Supplier Deviation Disposition Request

PROJECT: River Protection Project Waste Treatment Plant

Title of SDDR: PSV DEMISTER / MISC. DESIGN CHANGES
VESSELS

J2662 SDDR-001 Attachment for the Deviation Description and Proposed Disposition and Technical Justification:

JOSEPH OAT CORPORATION 2500 BROADWAY CAMDEN, N.J.	
JOB No: J-2662-A/B/C	SDDR: SDDR001
ENG:	DATE:
DRAWN: PJH	DATE: 12/11/08
SK. No: SDDR001-SK-01	REV: 0

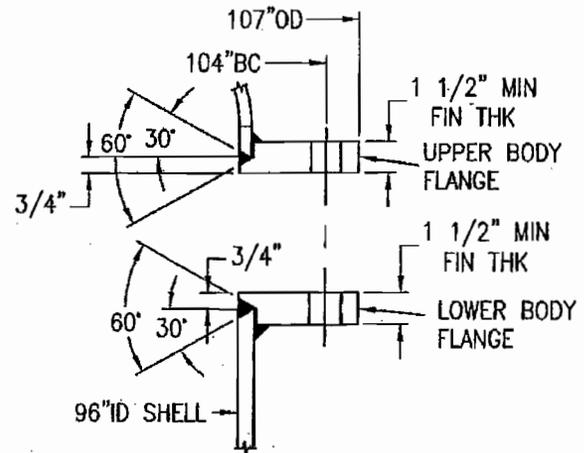
1 Body Flange Joint to Shell

The body flange design called out in BNI drawing 24590-PTF-MV-PJV-00002001 Rev.0 "Detail 1" in zone E-5 and F-5, is changed to full penetration on the I.D side and additional full NDE of this weld compared to the original design. See attached sketch of SDDR001-sk-01 for details.

Proposed disposition is "Use-as-is". The body flange configuration is in accordance with Appendix Y of ASME section VIII, Div 1. The proposed alternate body flange design improves the ID weld from fillet to full penetration weld with NDE test; the new flange ID line up with the shell ID without changing the original flange outside diameter or the bolt circle and seal ring location.

JOSEPH OAT CORPORATION 2500 BROADWAY CAMDEN, N.J.	
JOB No: J-2662-A/B/C	SDDR: SDDR001
ENG:	DATE:
DRAWN: PJH	DATE: 12/11/08
SK. No: SDDR001-SK-02	REV: 0

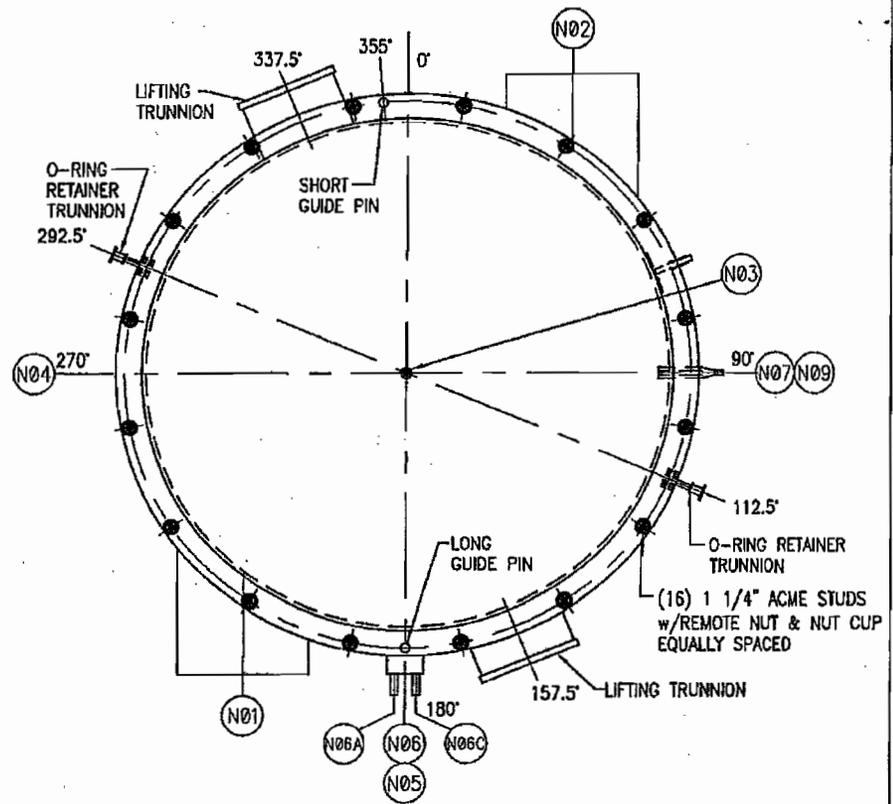
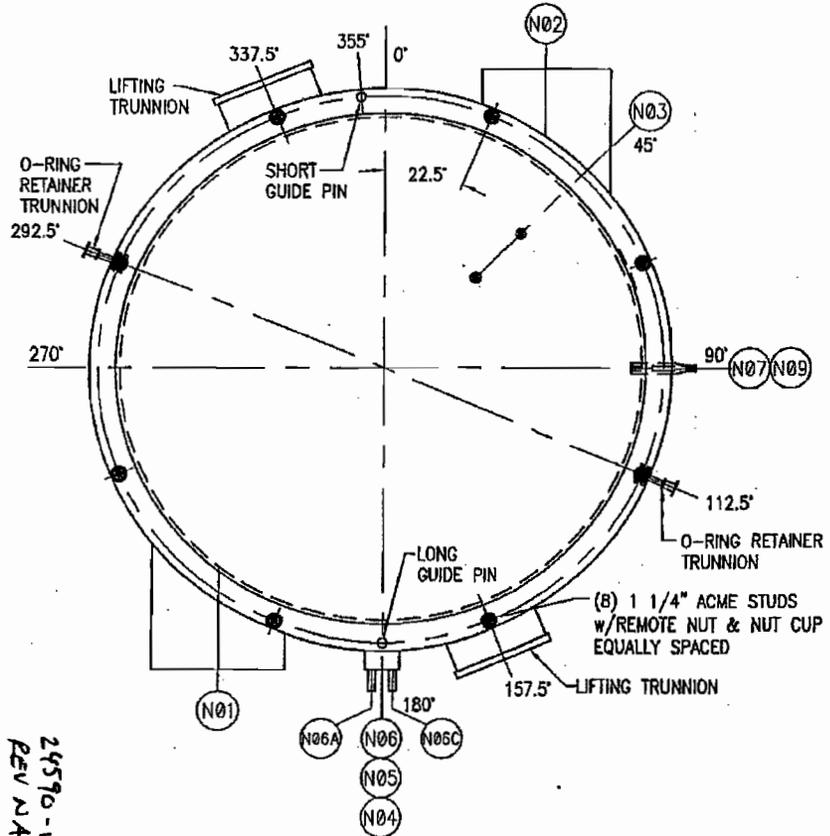
4 Body Flange ACME Stud Length

The ACME stud upper thread section length, called out in BNI drawing 24590-PTF-MV-PJV-00002001 Rev.0 "Detail 7" in zone D-5, is changed from 4" to 4-3/8" compared to the original design.

Proposed disposition is "Use-as-is". The proposed longer upper thread section is to accommodate the increased Retainer Ring thickness (see item 5 below in this SDDR) and any reasonable extra thickness of the body flange beyond the specified minimum thickness (no maximum thickness specified).

JOSEPH OAT CORPORATION 2500 BROADWAY CAMDEN, N.J.	
JOB No: J-2662-A/B/C	SDDR: SDDR001
ENG:	DATE:
DRAWN: PJH	DATE: 12/11/08
SK. No: SDDR001-SK-03	REV: 0

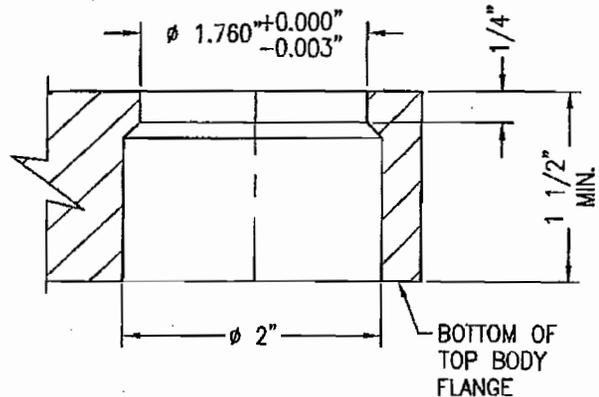
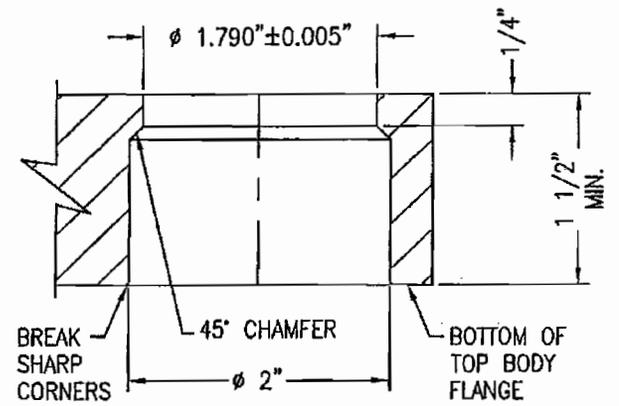
3 Upper Body Flange Dowel Pin Hole Size

The upper body flange Dowel pin hole top diameter, in BNI drawing 24590-PTF-MV-PJV-00002001 Rev.0 "Section B-B" in zone G-5 and H-5, is changed from 1.760" to 1.790"±0.005". See attached sketch of SDDR001-sk-03 for details.

Proposed disposition is "Use-as-is". The proposed new diameter does not affect the alignment of the top head assembly to the lower shell section of the vessel, nor any impact to the internal demister assemblies.

JOSEPH OAT CORPORATION 2500 BROADWAY CAMDEN, N.J.	
JOB No: J-2662-A/B/C	SDDR: SDDR001
ENG:	DATE:
DRAWN: PJH	DATE: 12/11/08
SK. No: SDDR001-SK-05	REV: 0

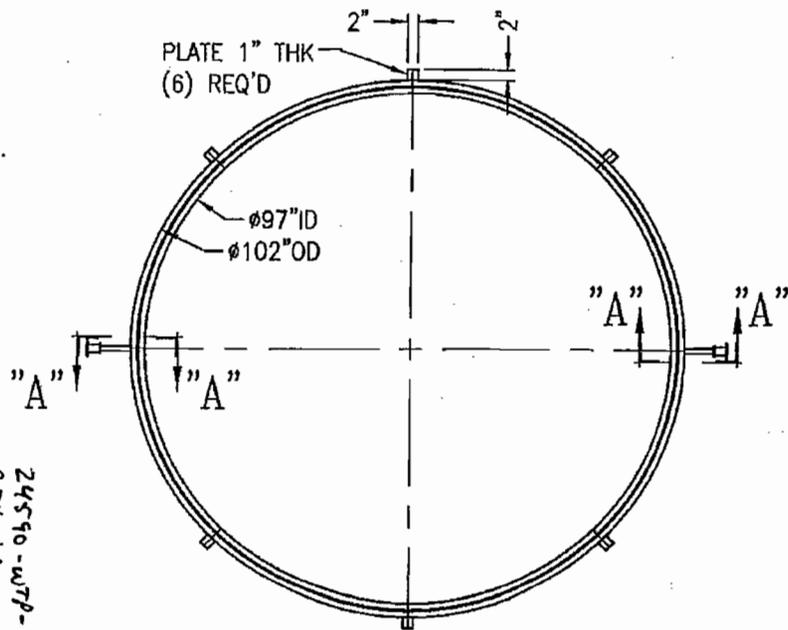
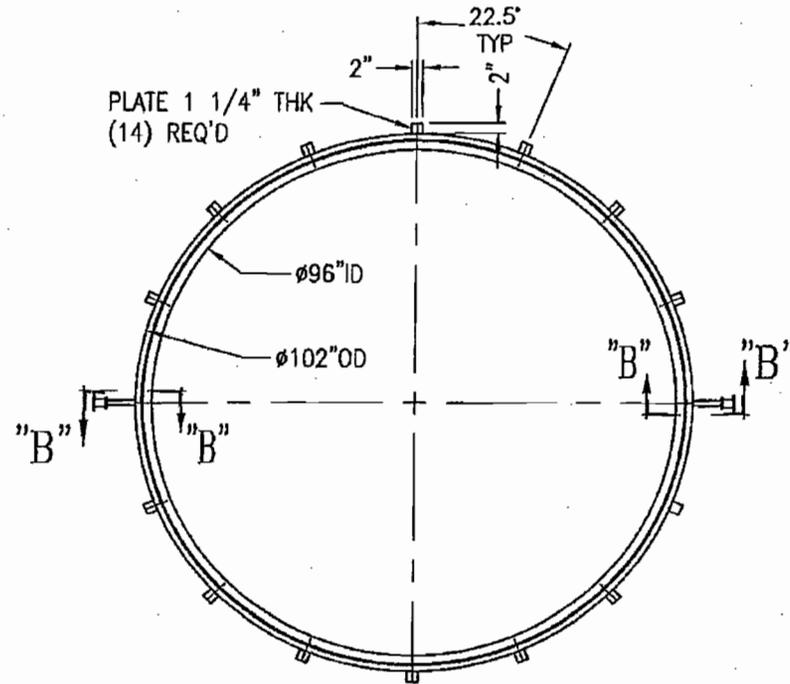
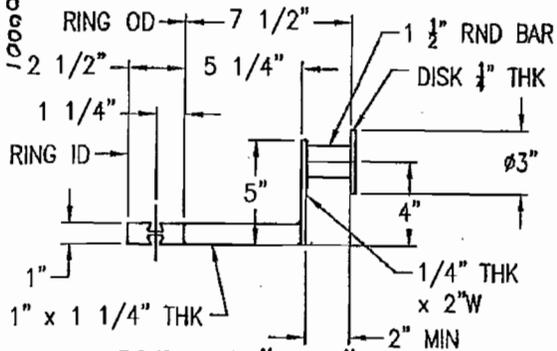
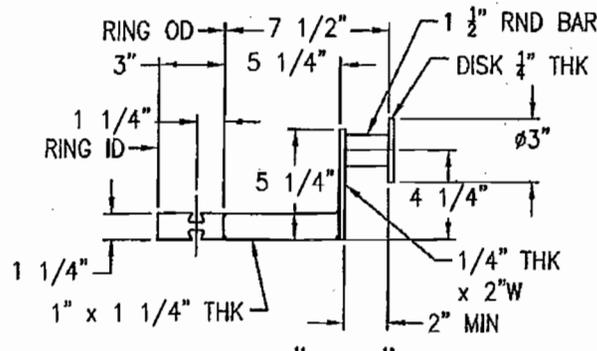
5 Retainer Ring

The Retainer Ring design in BNI drawing 24590-PTF-MV-PJV-00002002 Rev.0 is changed from 1" thick and 2.5" wide to 1-1/4" thick and 3" wide. The spacer block is changed from quantity of 6 to 14 because of the body flange stud quantity change and the thickness is change from 1" thick to 1-1/4" thick as well. See attached sketch of SDDR001-sk-05 for details.

Proposed disposition is "Use-as-is". The proposed new thickness and width of the retainer ring will meet the sealing O-ring requirements and line the top head and lower shell ID better. The increased thickness and quantity of the spacer blocks will suit to the ACME stud quantity change and the Retainer Ring thickness change.
